Code status

Mike Gothard
Project Manager
May 25, 2005

Code Activities

FIG. 1WB-2500-8 SIMILAR AND DISSIMILAR METAL WELDS IN COMPONENTS, NOZZLES, AND PIPING
(CONT'D)
(1/2 in. = 13 mm, 1/4 in. = 6 mm)

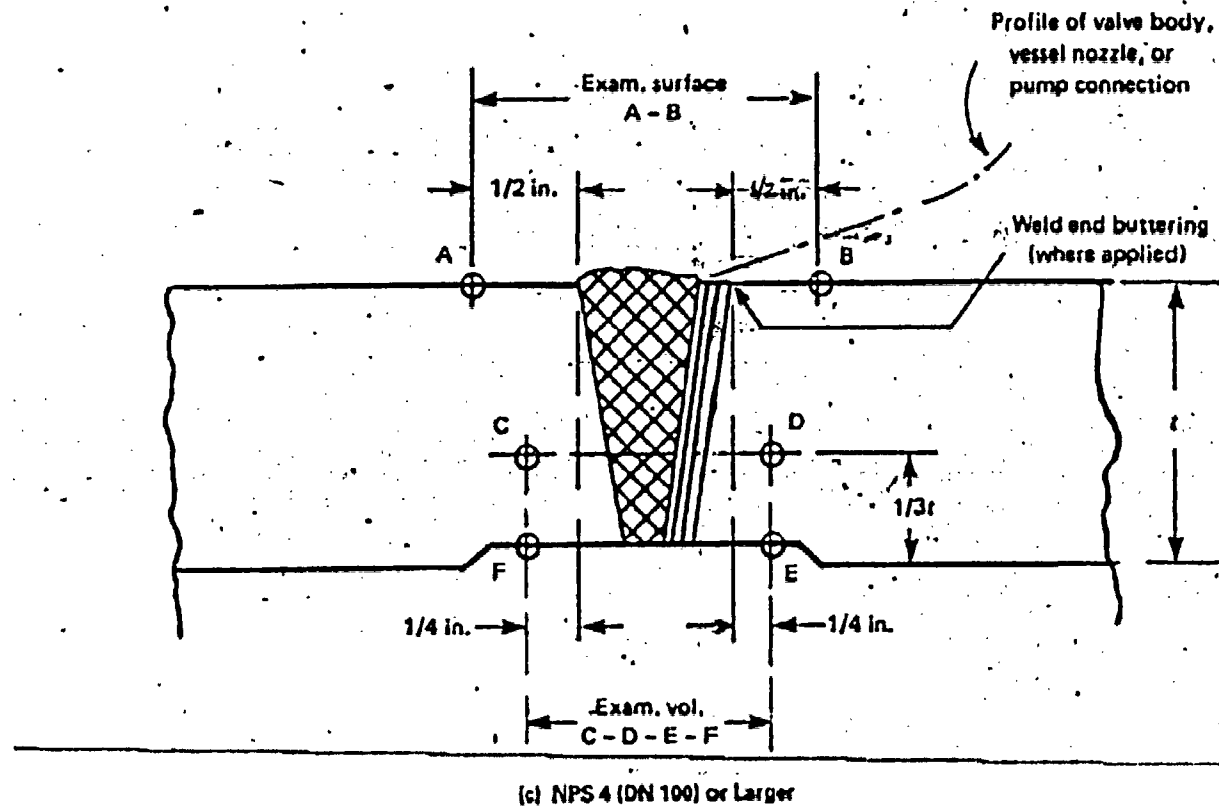
Code status – IWB-2500-8c

Note, when weld end buttering is present on both sides, the examination surface and volume shall be measured from the end of both butterings. It may include remnants of replaced welds, and may appear artificially deep on exposed surfaces due to fabrication processes. Buttering thickness may be determined from manufacturer's drawings or presumed to be 1/2 in. if true dimension is unknown.

FIG. IWB-2500-7(a) NOZZLE IN SHELL OR HEAD
 (Examination Zones in Barrel Type Nozzles Joined by Full Penetration Corner Welds)
 ($\frac{1}{2}$ in. = 13 mm)

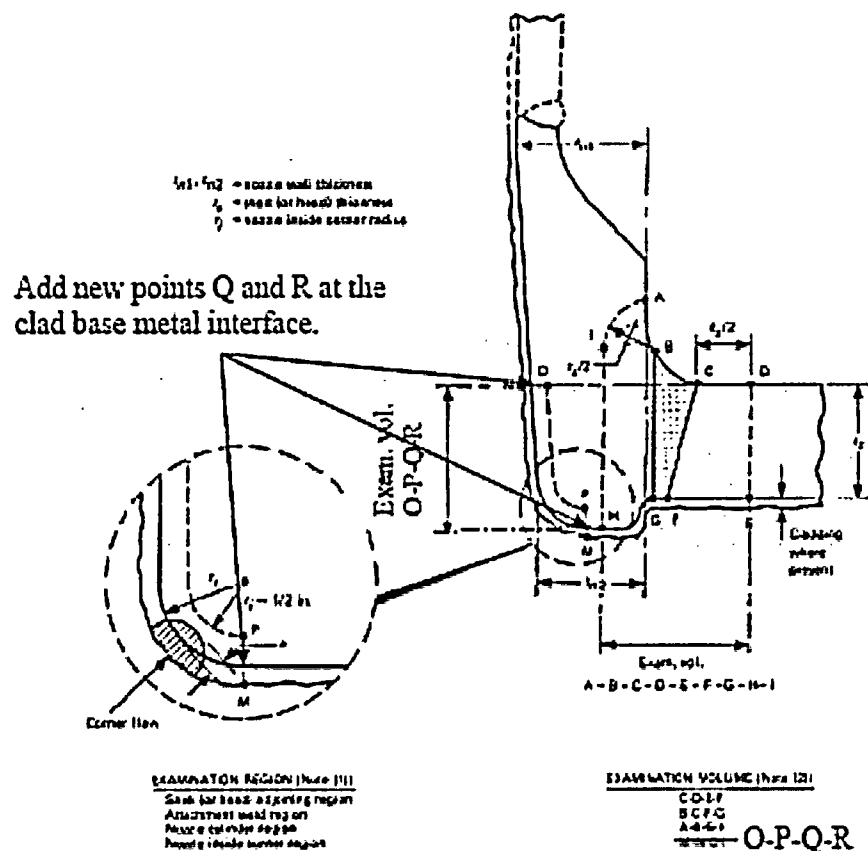
Code status – IWB-2500-7x
